Access Compliance Report

Public Rights-of-Way

(Curb Ramps)

Intersection ID: N/A	Main Street: RIDGE_OAK_DR	Cross Street: CAROLINA_CROSSING_DR	Location: NW
ADA ID: BCA5F40345FE	Ramp Type: Perp	Initial Pass/Fail: Fail	Overall Compliance: No
Severity Score: 10			
Codes/Mitigation Info/Possible Solution		Field Measurements/Component Compliance

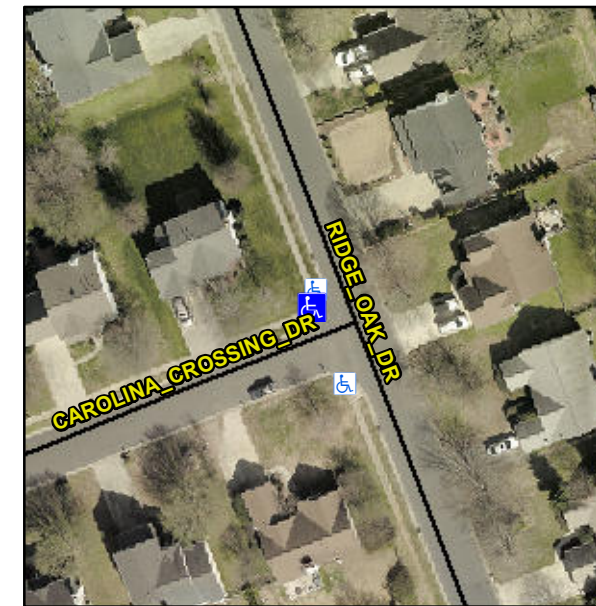
Not Found, R304.5.1, R304.5.3

Compliance	Description	Data	Compliance	Description	Data
N/A	Ramp Length (in)	91.0	Yes	Ramp Slope (%)	6.0
No	Ramp Width (in)	40.0	No	Ramp XSlope (%)	3.6
N/A	Flare Type LT	N/A	N/A	Flare Type RT	N/A
N/A	Flare Slope LT (%)	N/A	N/A	Flare Slope RT (%)	N/A
N/A	Flare Traversable LT?	N/A	N/A	Flare Traversable RT?	N/A
N/A	Landing Length (in)	N/A	N/A	DWS Provided?	N/A
N/A	Landing Width (in)	N/A	N/A	DWS Contrast?	N/A
N/A	Landing Slope (%)	N/A	N/A	DWS Length (in)	N/A
N/A	Landing X Slope (%)	N/A	N/A	DWS Full Width?	N/A
N/A	Landing Curb? (Y/N)	N/A	N/A	DWS Offset (in)	N/A
N/A	Shared Landing?	N/A			
N/A	Gutter Ponding?	N/A	N/A	Gutter Slope (%)	N/A
N/A	Gutter Lip Ht (in)	N/A	N/A	Gutter X Slope (%)	N/A
N/A	Painted X Walk1?	No	N/A	Painted X Walk2?	N/A
	X Walk 1 Direction	To SE		X Walk 2 Direction	N/A
N/A	X Walk 1 Width (in)	N/A	N/A	X Walk 2 Width (in)	N/A
	X Walk 1 Slope (%)	1.0		X Walk 2 Slope (%)	N/A
	X Walk 1 X Slope (%)	1.5		X Walk 2 X Slope (%)	N/A

Remove & Replace Entire Ramp.
